Addendum No. 1

Project: 2017 Renovations
Dillsboro Elementary
Dillsboro, Indiana

Proj. No: 1649.01

Date: August 11, 2017

Sheet
AD-1a

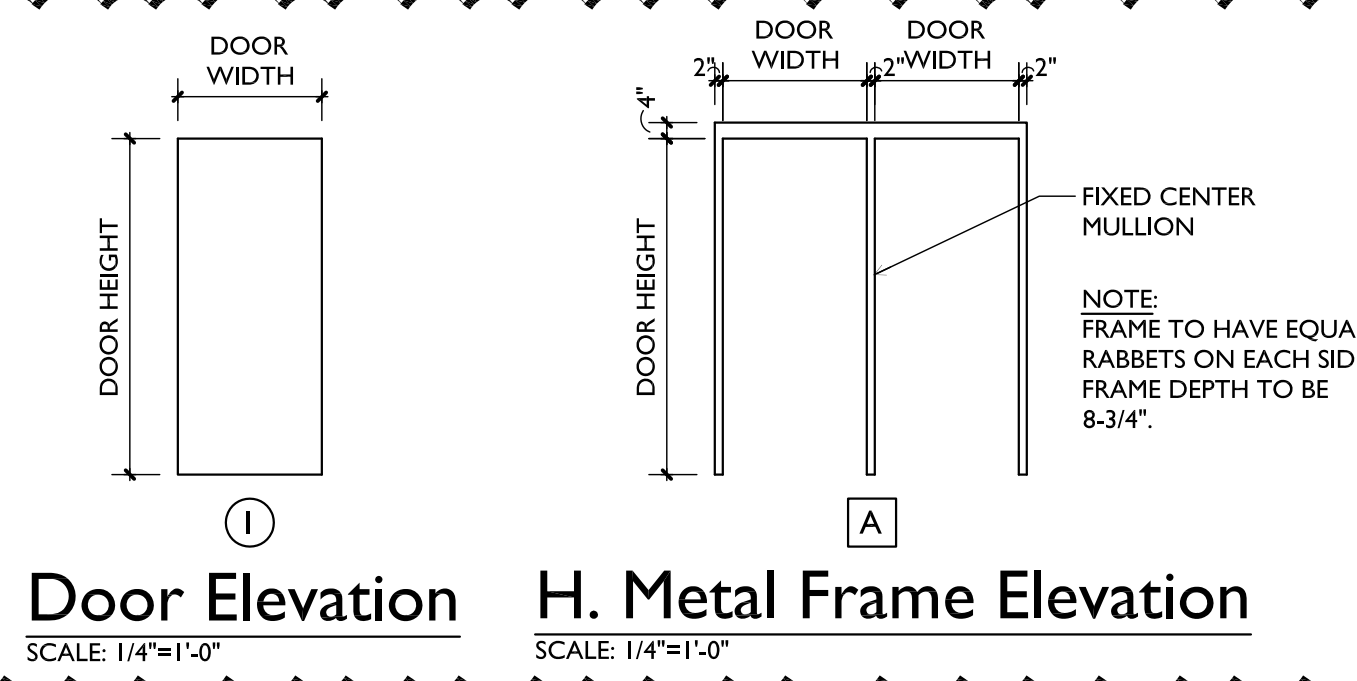
- b. Install new doors, frame, and hardware at Doors A103a and A103b per Drawing A-101
 - c. Relocate existing power and fire alarm connections for electromagnetic hold open at Door A103b as required to reverse door swing per Drawing AD-1c.

- 26. E-102
Alternate No. 9: Relocate electrical power and fire alarm for electromagnetic hold opens per attached Drawing AD-1a.

NOTE:
WORK ON THIS DRAWING TO BE
INCLUDED IN ALTERNATE NO. 9.

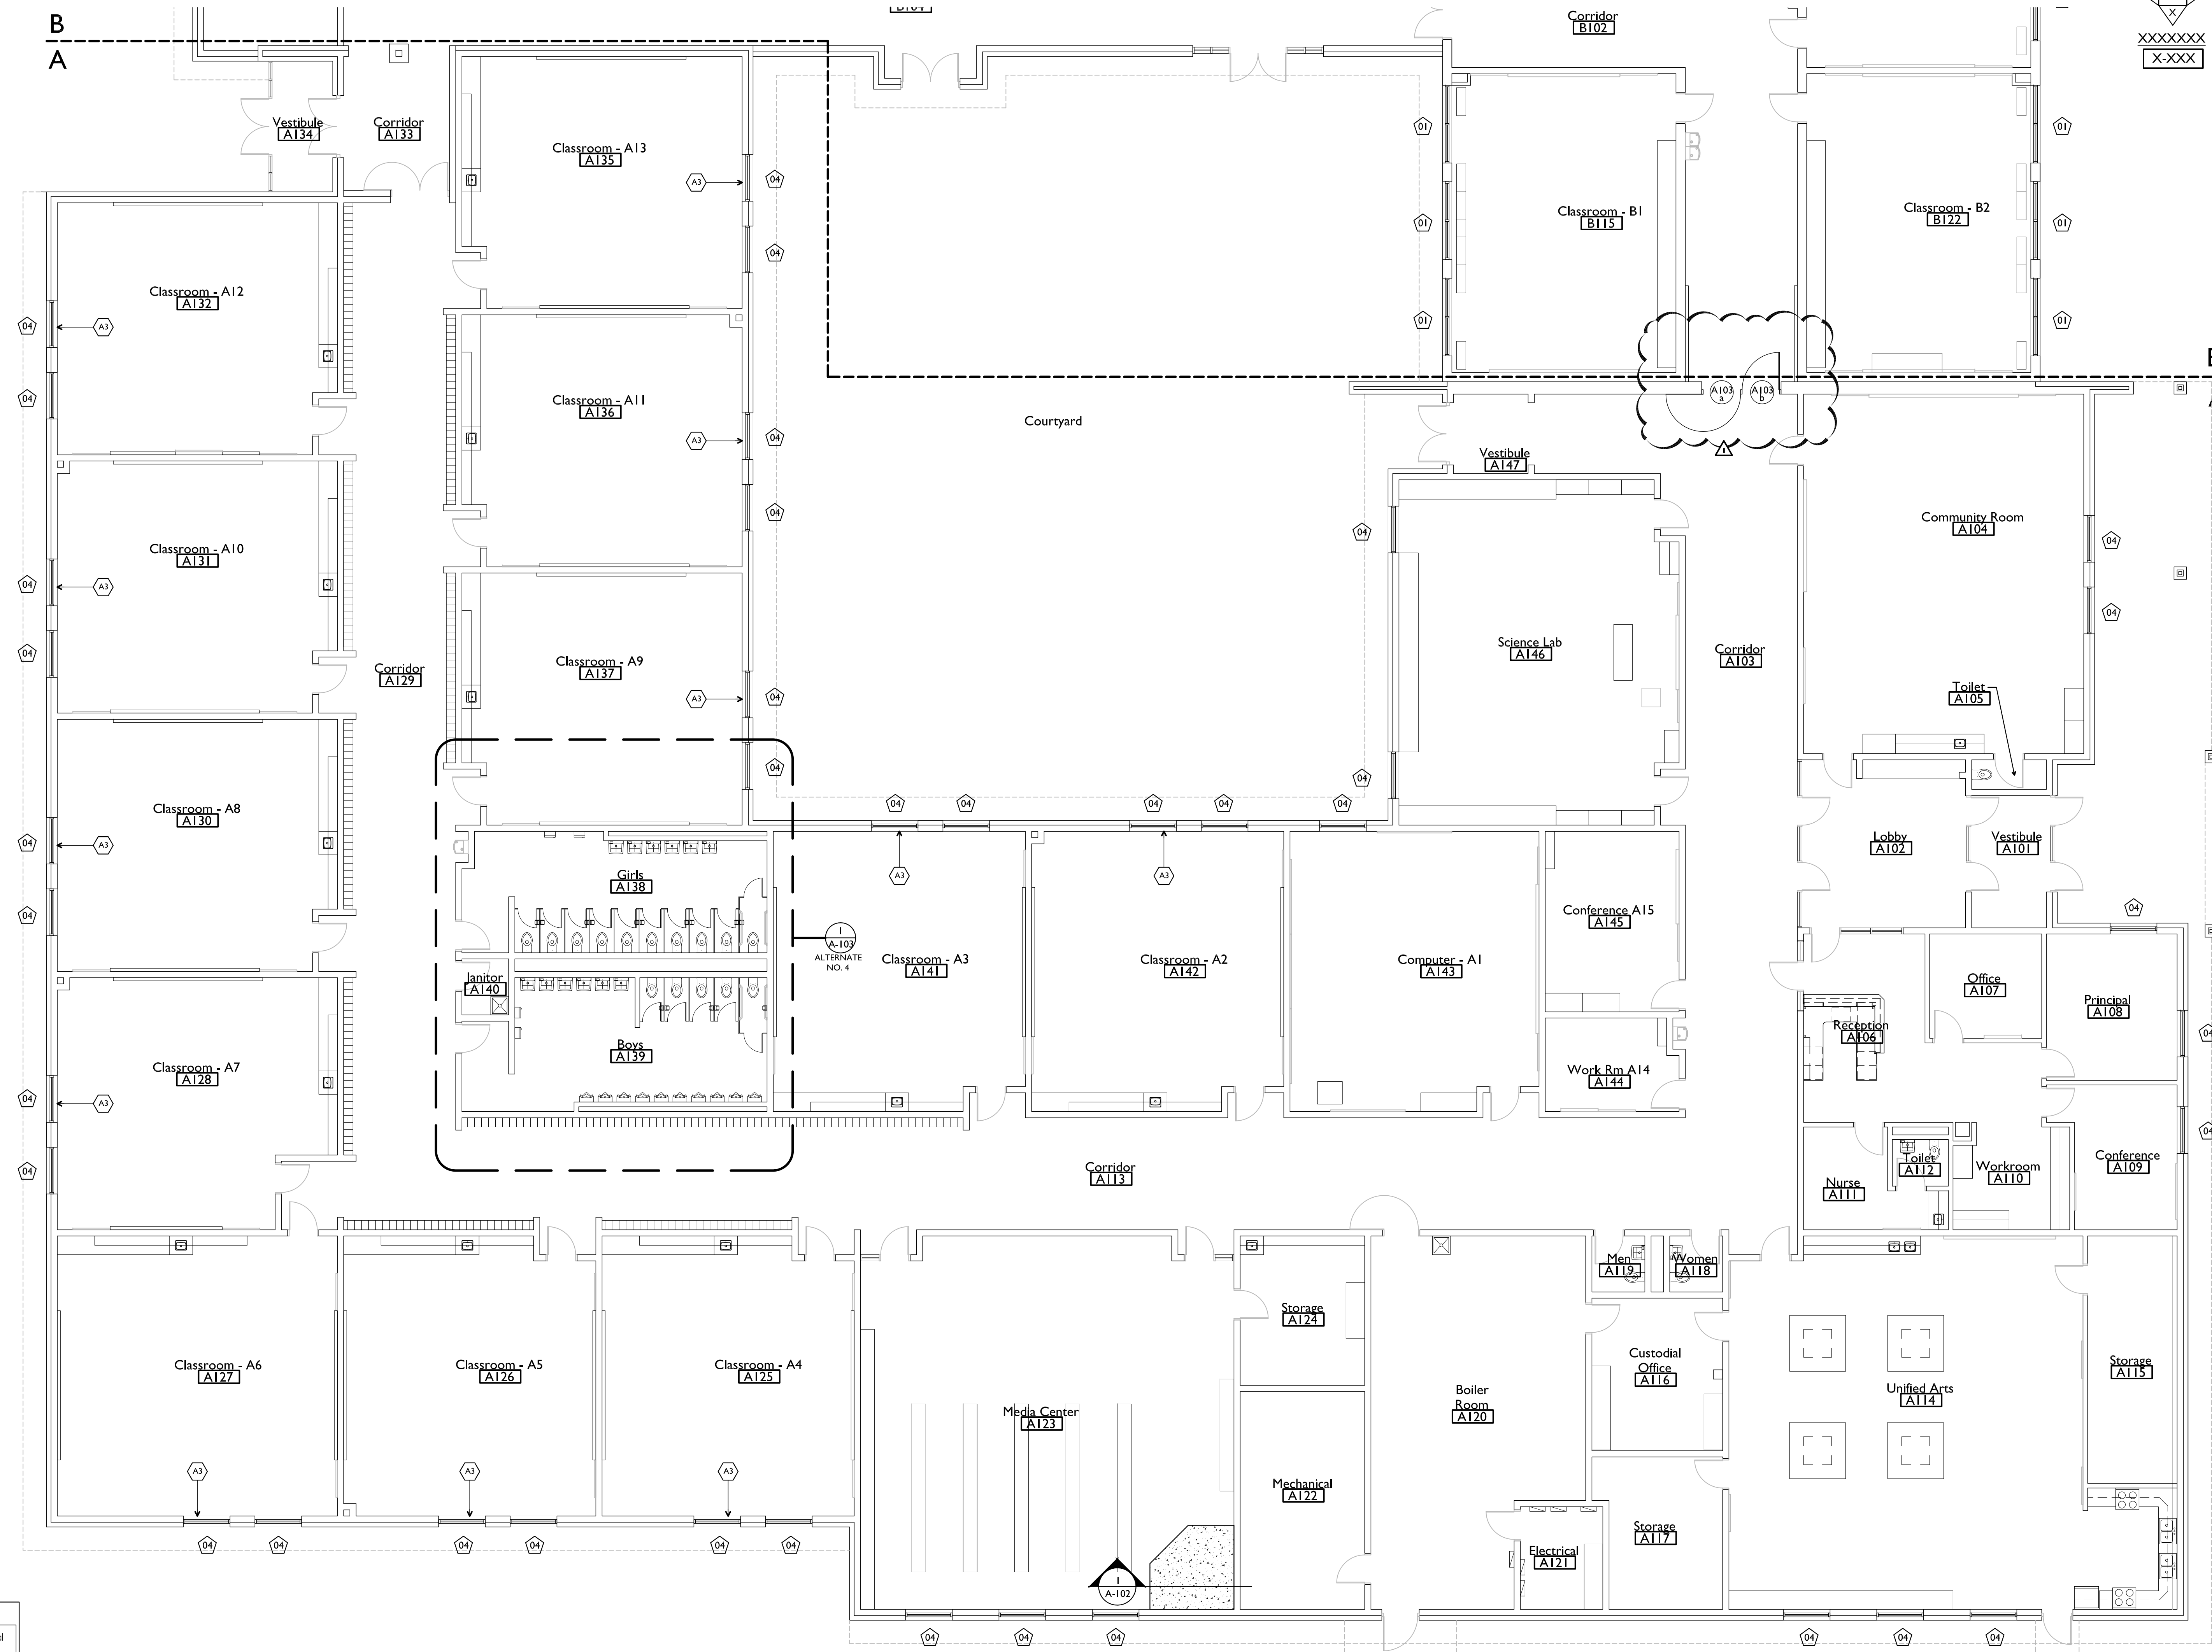
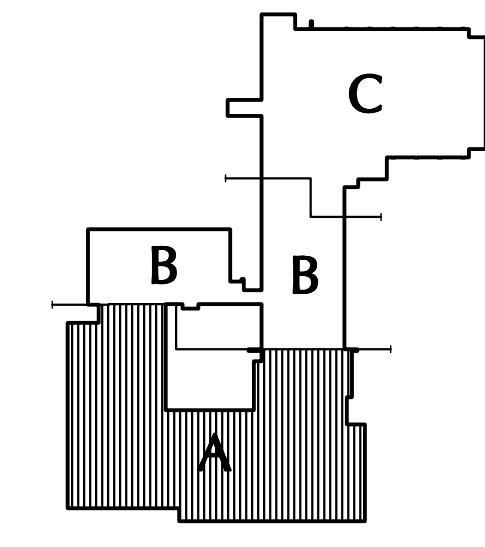
9. A-003: Area "C" Demolition Plan
Closet in Music (C116): Revise Demolition Plan Keynote "D8" to "D20."
10. A-101 Area "A" Architectural Plan
Replace existing drawing in its entirety with the attached drawing; refer to clouded areas for revisions.

NOTE
DOOR AND FRAME REPLACEMENT WORK
TO BE INCLUDED IN ALTERNATE NO. 9.

Sheet
E-001

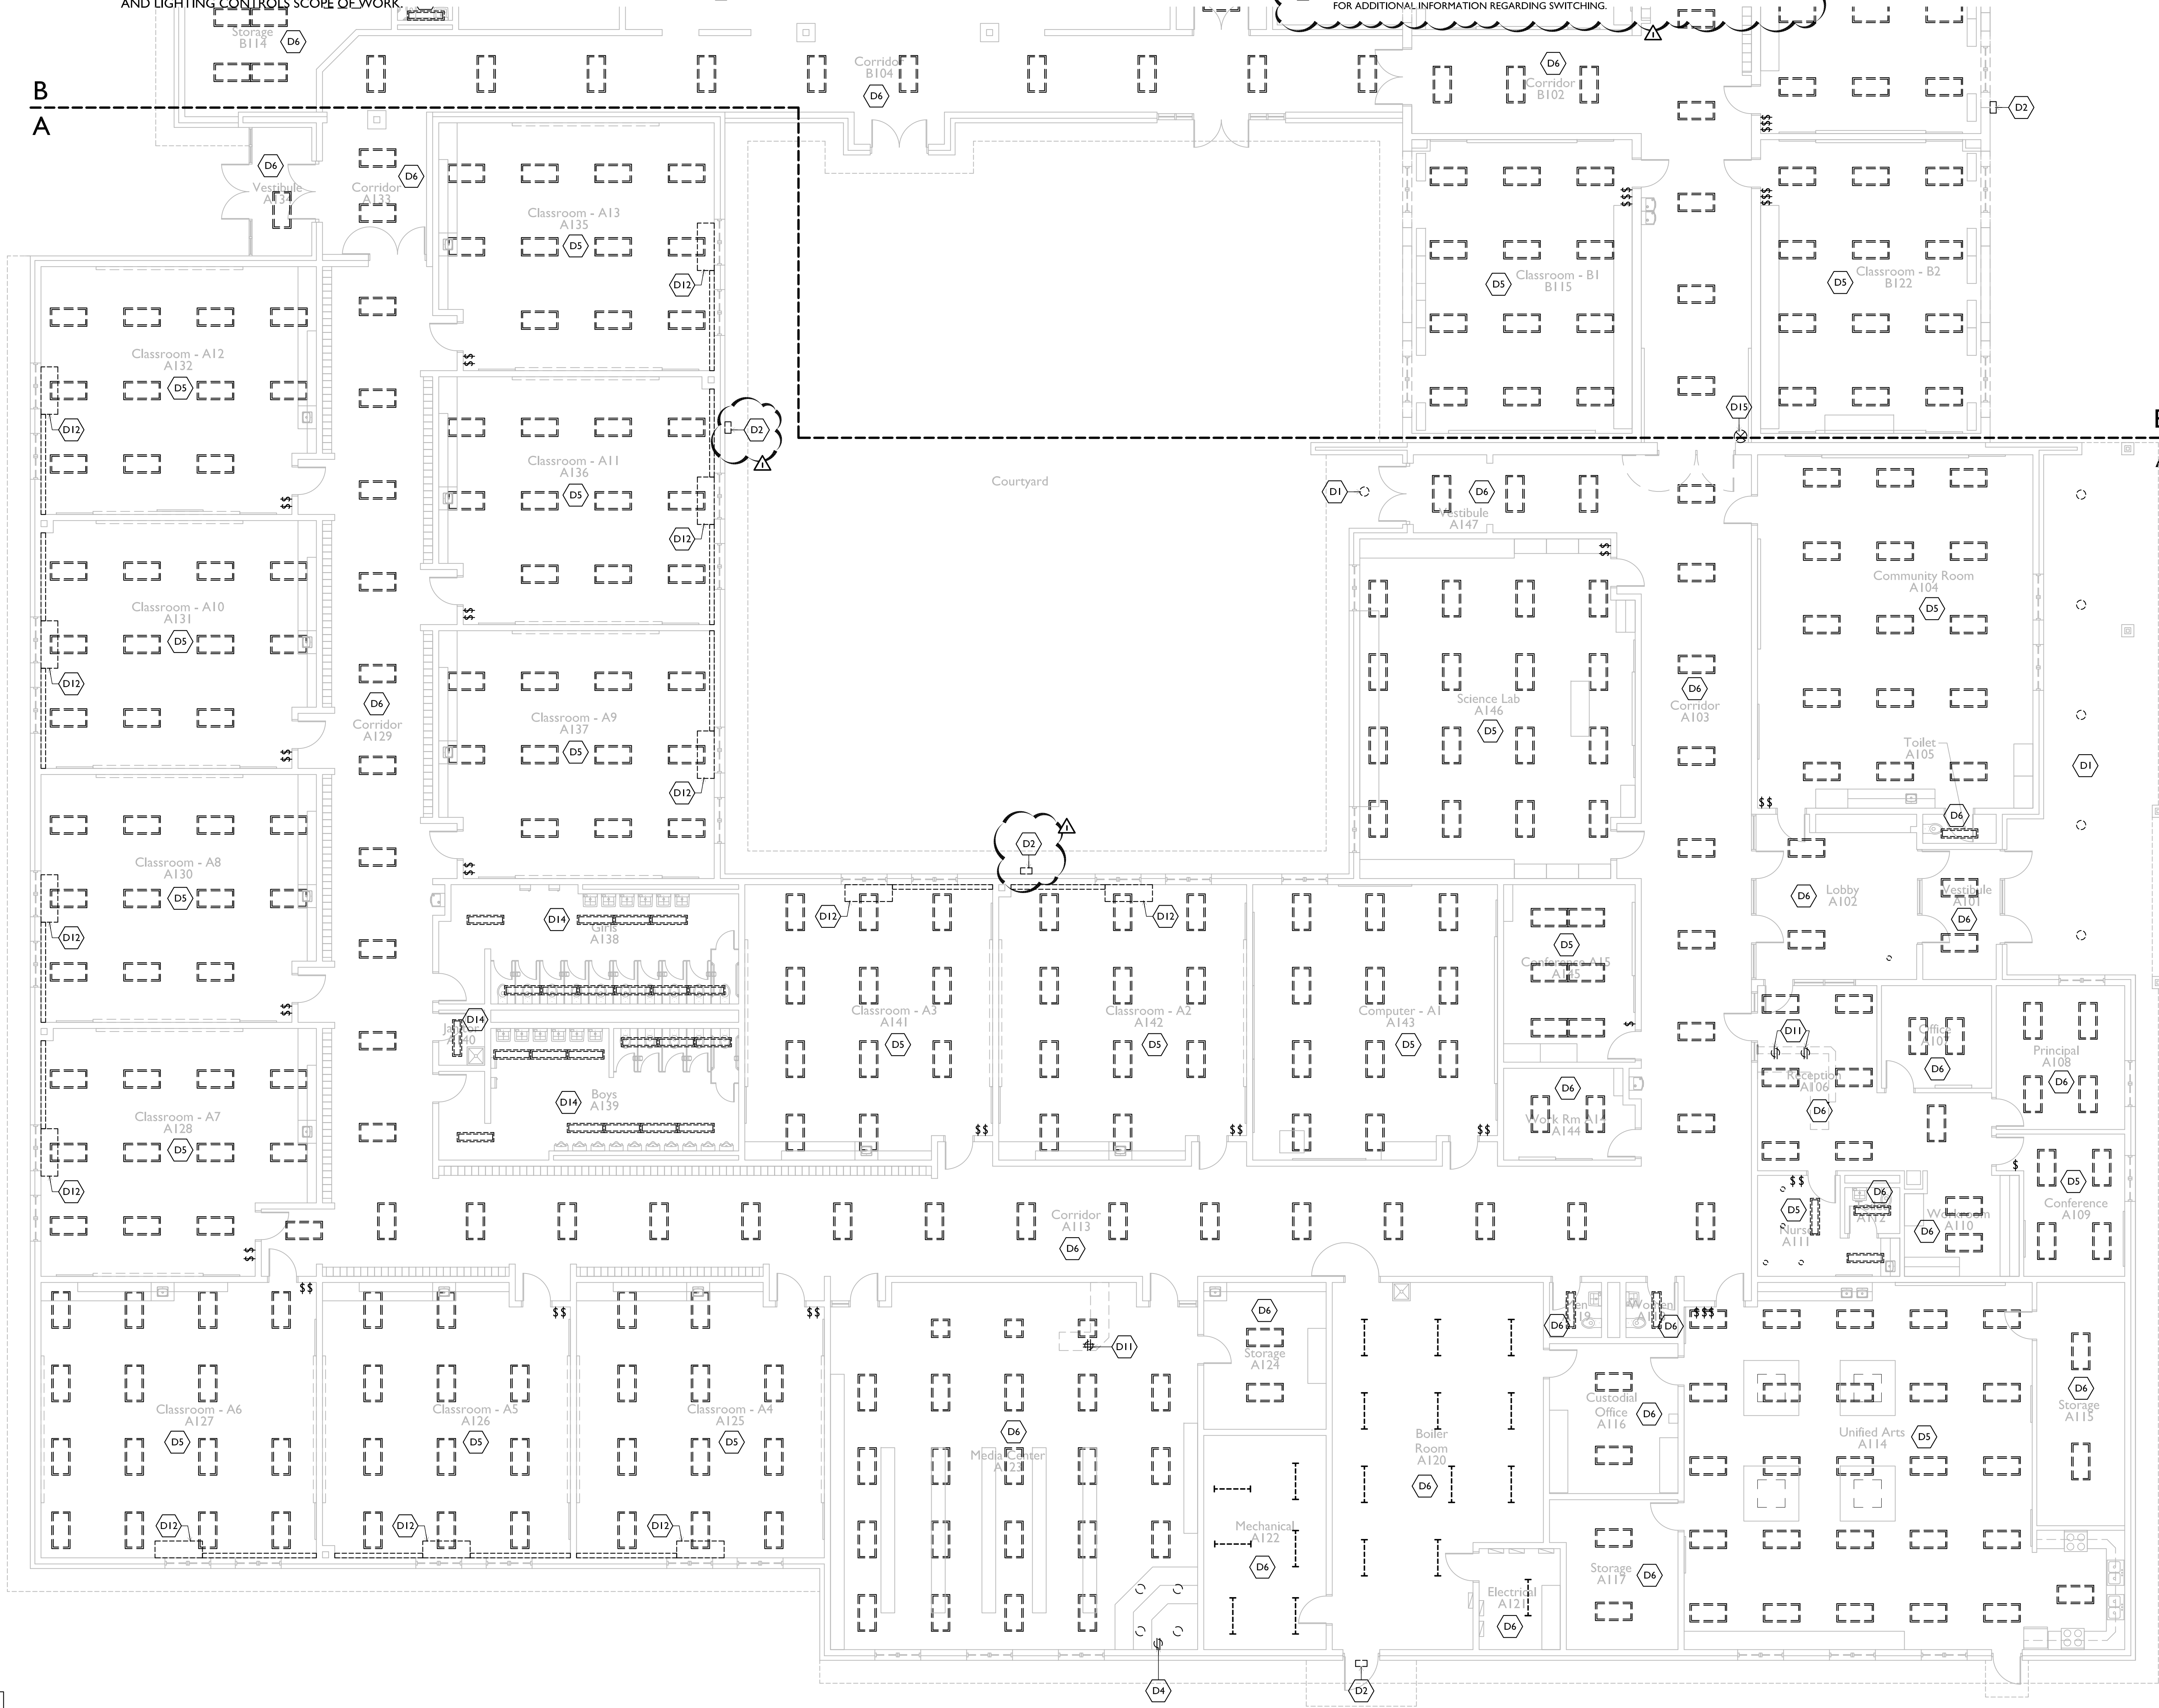
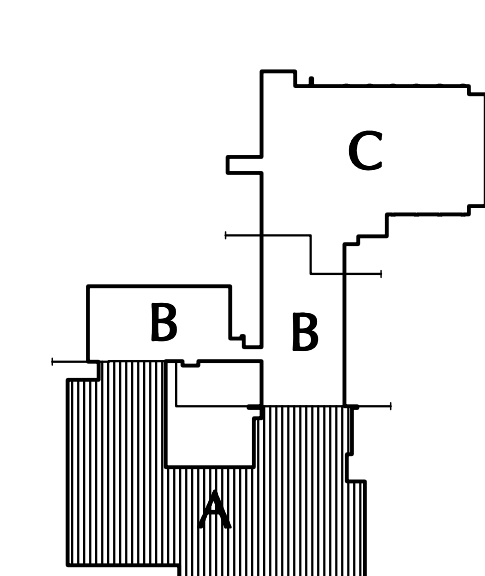
22. E-001 Area "A" Electrical Demolition Plan
Replace existing drawing in its entirety with the attached drawing; refer to clouded areas for revisions.
23. E-003:Area "C" Electrical Demolition Plan
Closet in Music (C116):Add Electrical Demolition Plan Keynote "D16" in room.
